September 21, 1978  
ALAB-179-78

MIDLAND NUCLEAR PLANT - ALAB-106  
MONTHLY REPORT FOR AUGUST 1978  
SHEET NOS 50-329 AND 50-330

LOG OF NONCONFORMANCE REPORTS

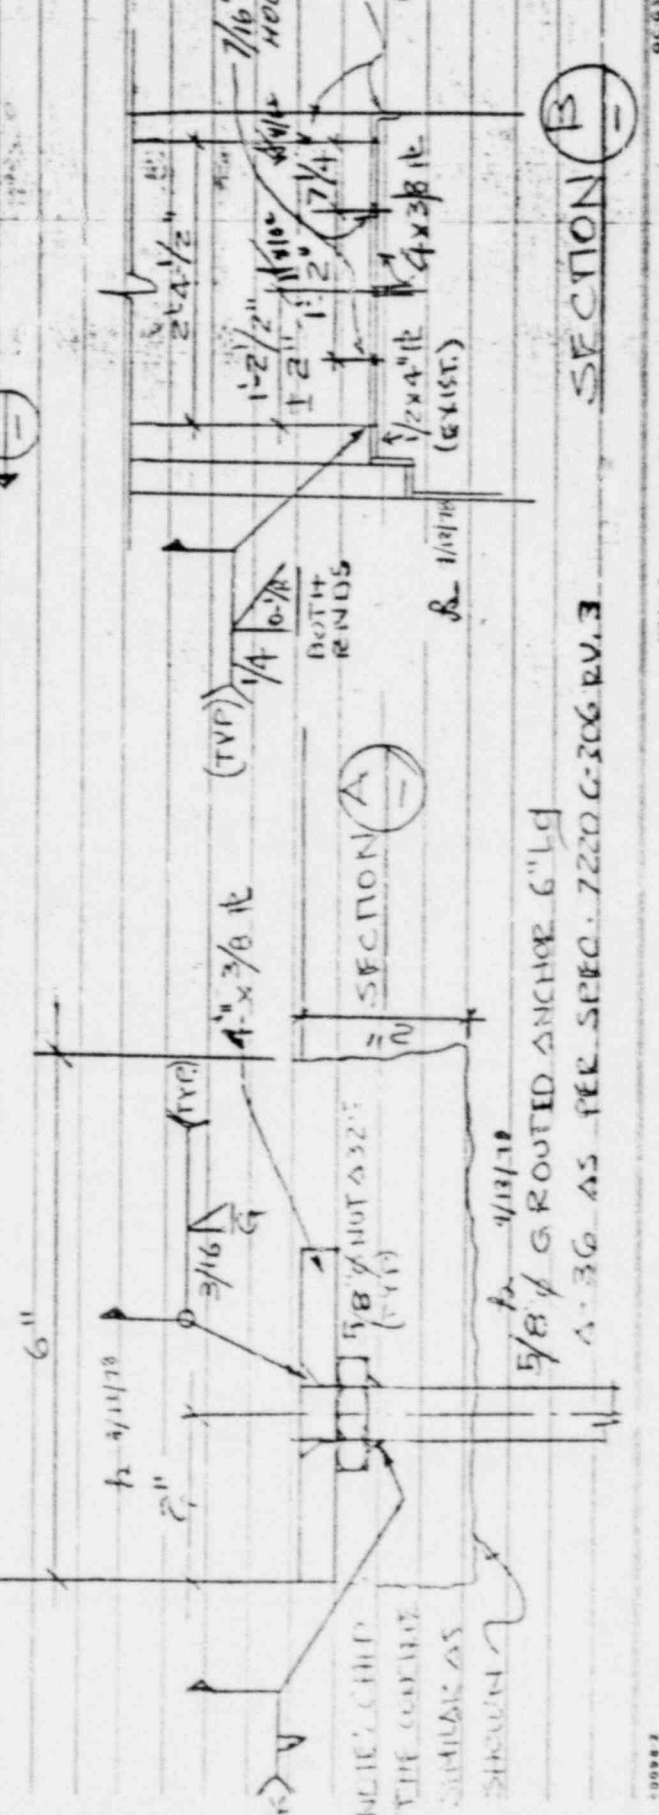
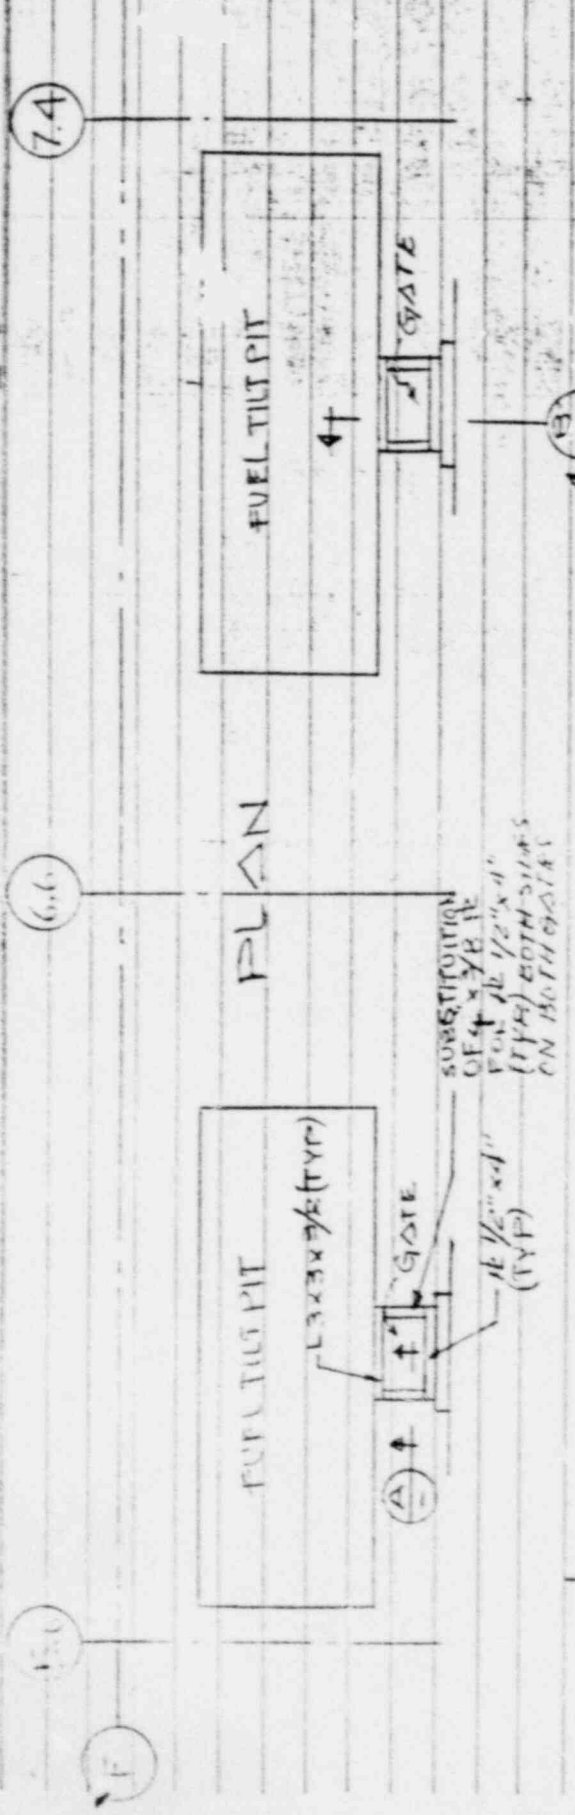
16. NONCONFORMING CONDITION: SECTION B, C-248(R), REUS CALLS OUT DETAIL 7 ON DWG. C-251 FOR THE EMBED PLATES AT THE BOTTOM CORNERS OF THE FUEL TILT PIT GATES. THIS DETAIL REQUIRES 1/2" x 4" IR'S TO RUN AROUND PERIMETER OF EXTERIOR CORNERS OF THESE GATE OPENINGS. SECTION THE GATE SHELF ON SOUTH FACE AND L 3/8" x 3/8" ON NORTH FACE. THESE IR'S WERE OMITTED ON BOTH SIDES OF BOTH GATES DURING CONSTRUCTION ATTACHED SKETCH - FIRST NO. 1, 2, 3, 4. ONE HOLD TAG APPLIED. HOLD IR'S ENGINEER'S DISPOSITION.

22. ( ) Field Engineering Disposition (X) Field Engineering Recommended Disposition to Project Engineering  
FIELD ENGINEERING RECOMMENDS: SUBSTITUTION OF PLATES 4" x 3/8" FOR MISSING PLATES 1/2" x 4", AS SHOWN ON ATTACHED SKETCH. Alberto 3/13/78

23. PROJECT ENGINEERING DISPOSITION: Structural capacity with added embed plates 3/8" 4" as called out in Block 22 and detailed on Page 2 of 2 of the NCR is adequate and no safety implications are involved. Therefore, Project Engineering concurs with Field Engineering recommended disposition.

Continued from page 1, block 16.

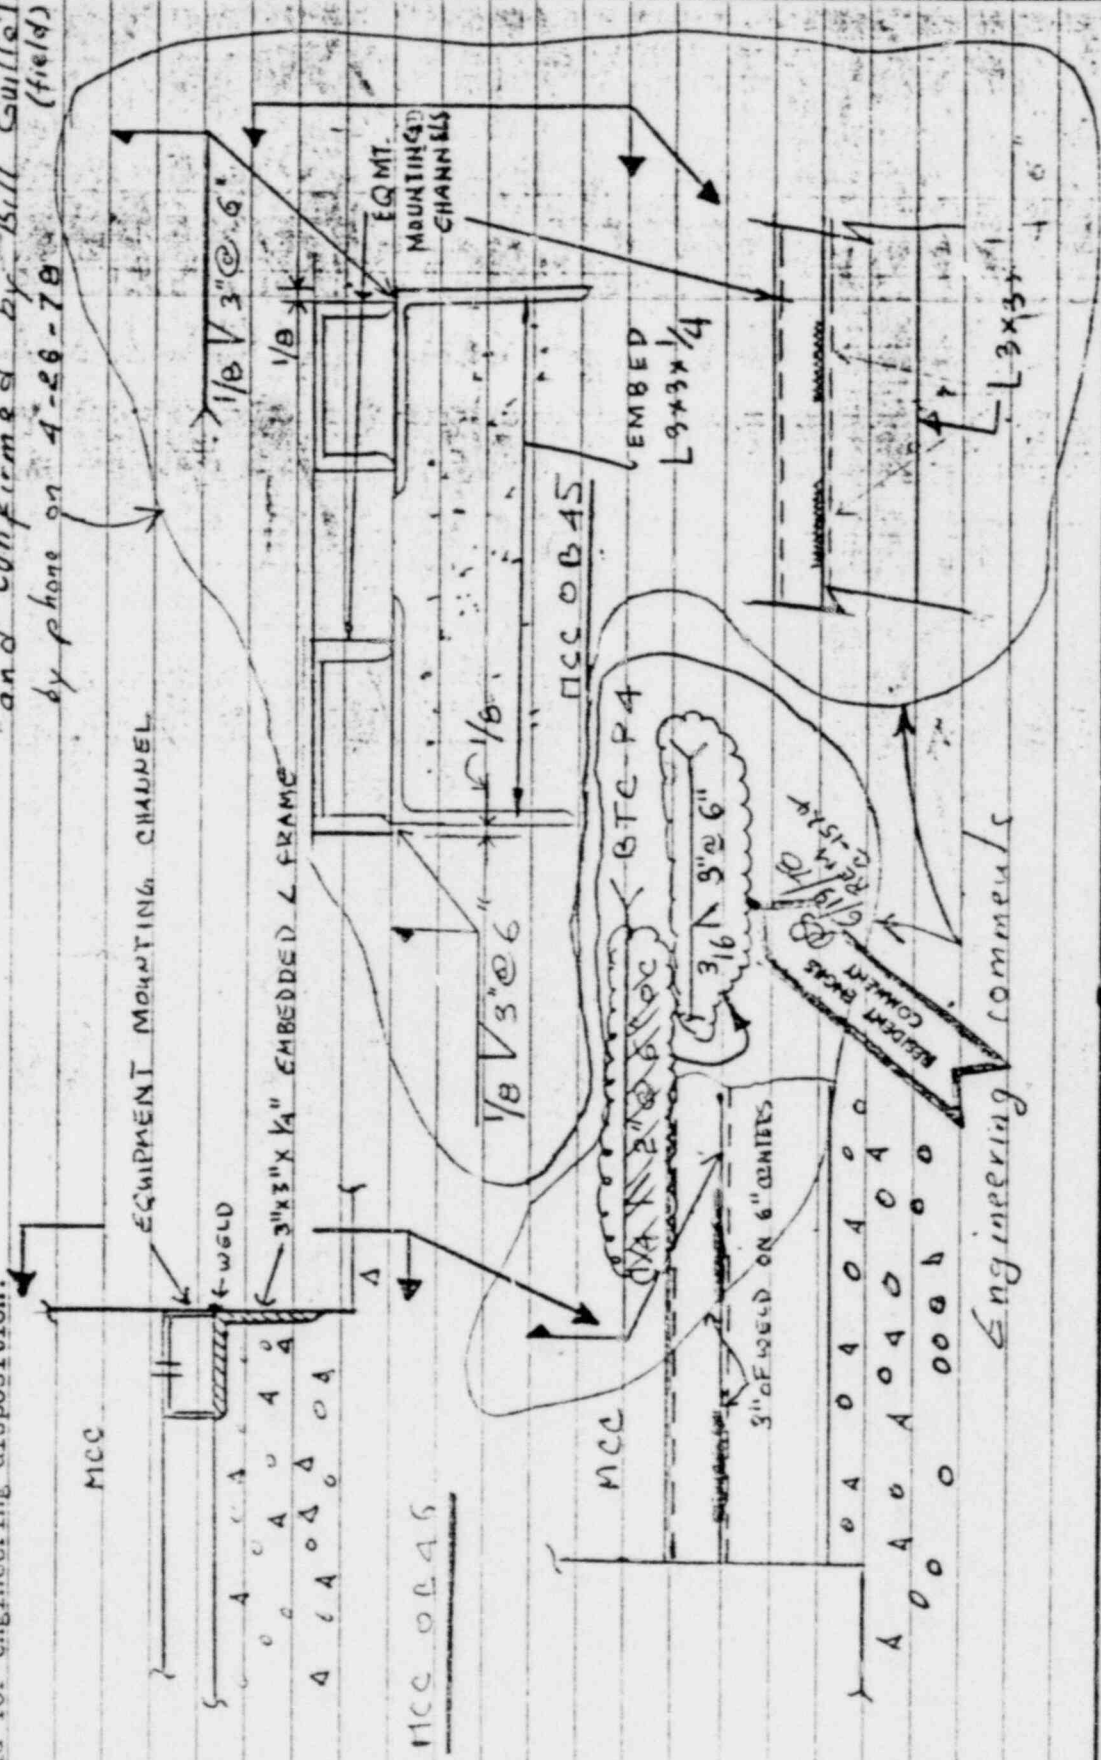
16. NONCONFORMING CONDITION: <b>Dwg. G186 (Q) Rev. 4 w/DCN #5, Equipment Location Plan at</b>			24. DISPOSITION CONCURRENCE			
<b>cl. 685', references Details 1 and 7, Dwg. G141 for mounting pad installation and equipment hold down for 480 Volt Motor Control Centers OB45 and OB46. Detail 1, G141 (Q) Rev. 5 shows cabinet plug welded into place and detail 7 shows 3/4" threaded studs, field located, for cabinet anchoring. Contrary to the above, the field has intermittently welded the face of the MCC cabinet mounting channels to</b> (Continued on page 2)			rework	reject	repair	use as is
			PROJECT FIELD ENGINEER <i>[Signature]</i>		DATE <b>4-17-78</b>

the face of the foundation pads angle frame, front and rear of cabinets.

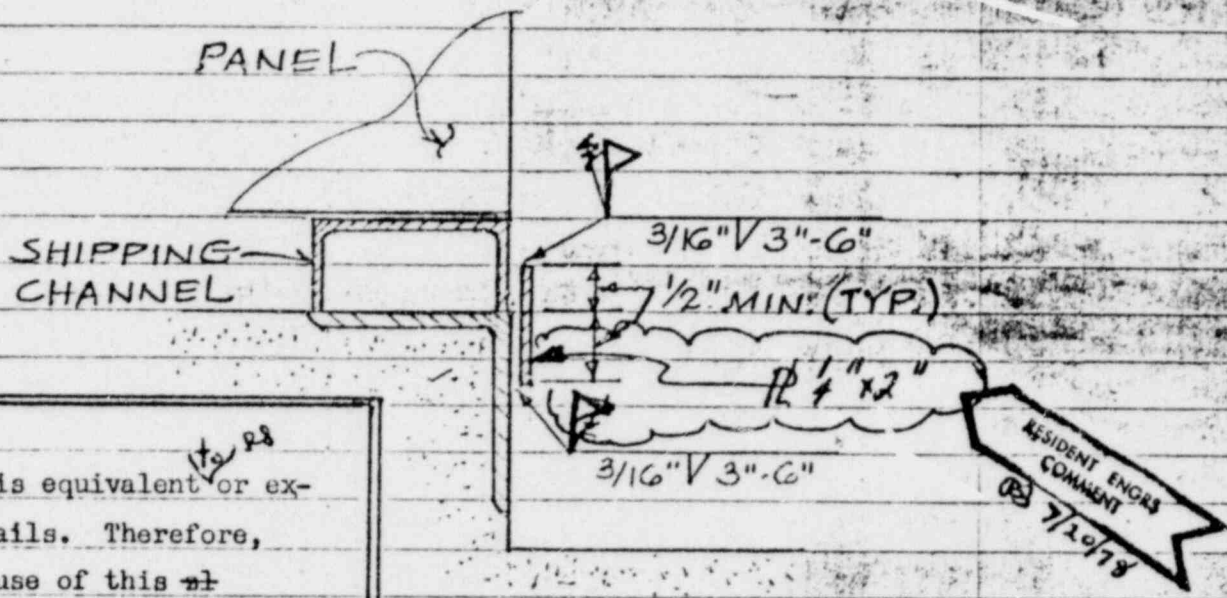
As an alternate to welding details on sheet 2, Field ~~recomm~~ recommends using a continuous 1/4" x 2" wide plate on <sup>either side 7/20/78</sup> both sides of the panels (see sketch below). This plate may be used in conjunction with the welding details on sheet 2. 7/20/78

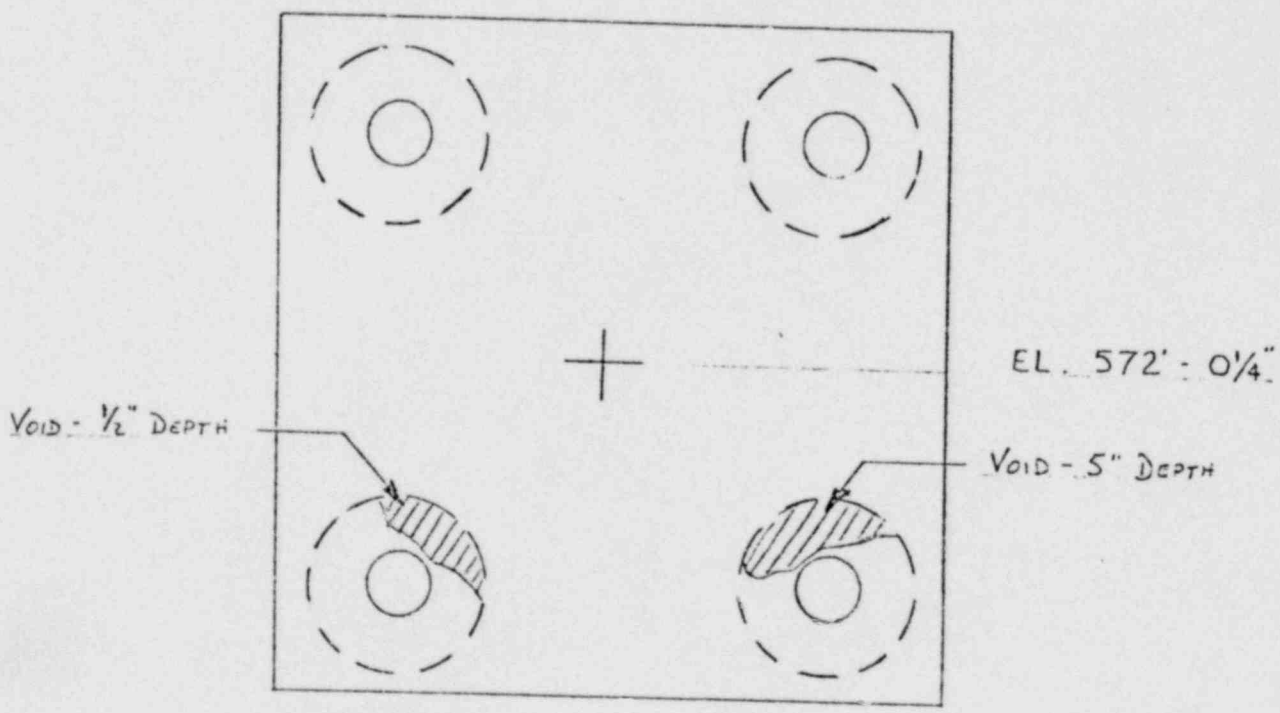
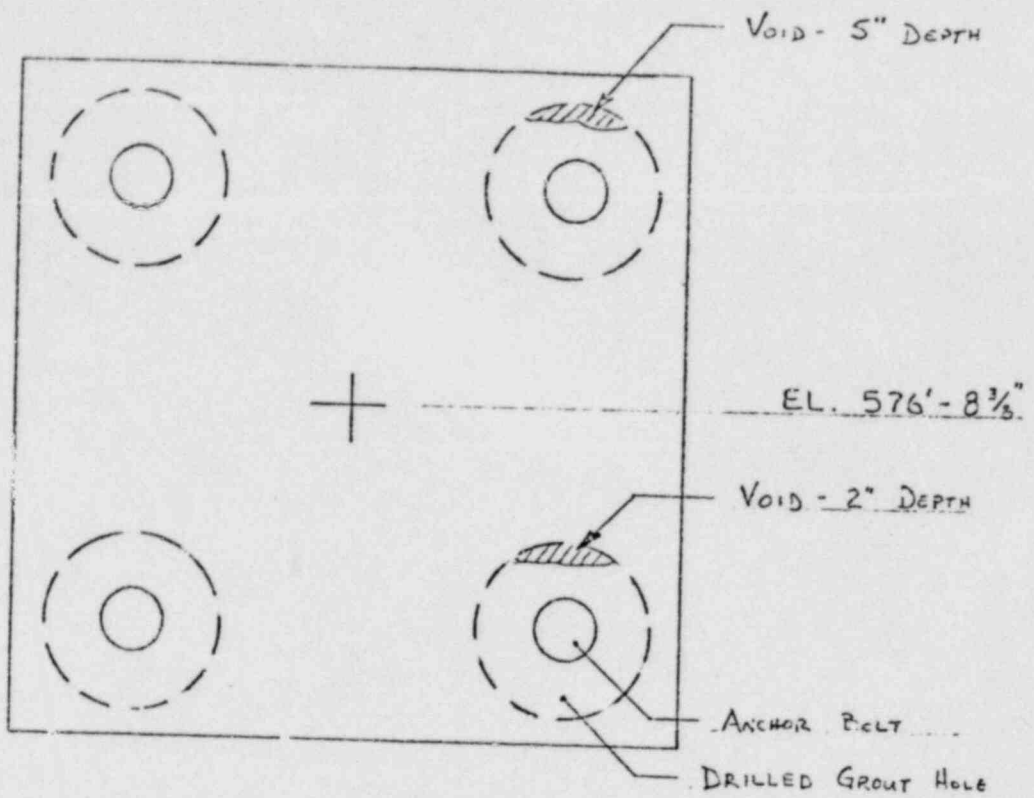
Contrary to the above, two 3/8" x 10" x 10" hangers, Mark #10-1FCB-34-H1, shown on ITT Grinnell sketch #i-610-4-1 were installed with grouted anchor bolts which were installed incorrectly. Four of the total eight grouted anchor bolt holes have voids. Two of the voids extend the entire depth of the drilled holes. This nonconforming condition was discovered due to a location change for the plates. Upon removal of the plates, a full visual inspection could be performed and the voids were discovered by CPCo during routine surveillance. See attached sketch.

Also, the design of the grouted anchor bolts is conservative to compensate for anticipated difficulties during their installation. This conservatism is in the form of the following factors.

- a. The grouted anchor bolts are designed with a safety factor of 4 on the ultimate pull-out capacity on the grout concrete contact area.
- b. Many of the grouted anchor bolt assemblies have more than the designed number of anchor bolts in order to maintain stability and symmetry.
- c. The actual strength of the concrete and the grout is greater than the design strength of the concrete and the grout respectively, thereby, increasing the capacity of the anchor.

In order to provide assurance that the remainder of the installed anchor plate assemblies were satisfactory for the design conditions, Project Engineering requested that an additional 23 anchor plate assemblies be removed and the anchor bolt grouting be visually examined and photographed.
